SERVICE AND APPLICATION NOTES

iHarmony® Zoning System Wiring Change (Alert Code 120)

(ACC-15-01)

Figure 1. iComfort Wi-Fi® and iHarmony® Zoning System

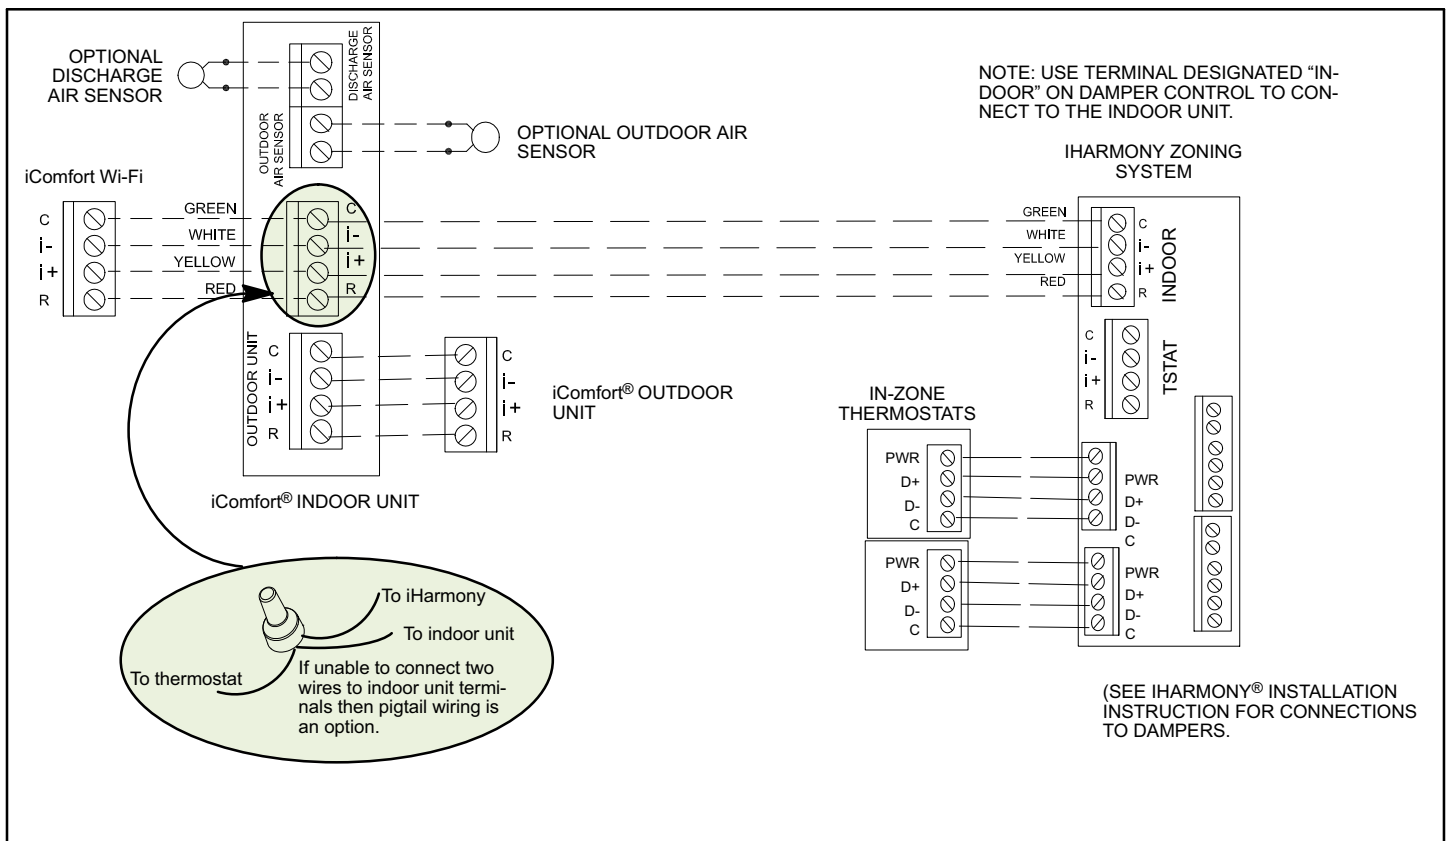
Alert Code 120 has been observed in system using existing wiring methods recommend for the iHarmony® Zoning System. This issue has been duplicated in our test facility and a recommended changed in the wiring method is required to reduce communication outages or delays between iComfort® system components.

- Connect either the iComfort Wi-Fi® or the iComfort® S30 Smart Hub (whichever is applicable) directly to the indoor iComfort® unit.
- Connect the iHarmony® Zoning System control directly to the iComfort® indoor unit. (This means no direct wiring to the thermostat terminals or Smart Hub from the iHarmony® zoning system damper control module).

If an existing system has demonstrated this issue, then it is highly recommended to use the new wiring method. The system may still work using the original wiring method, however the new recommended method will decrease line interfere in communications. Using the new wiring method will also result in a more stable and efficient system. Refer to figures 1 and 2 for using the recommended new wiring.
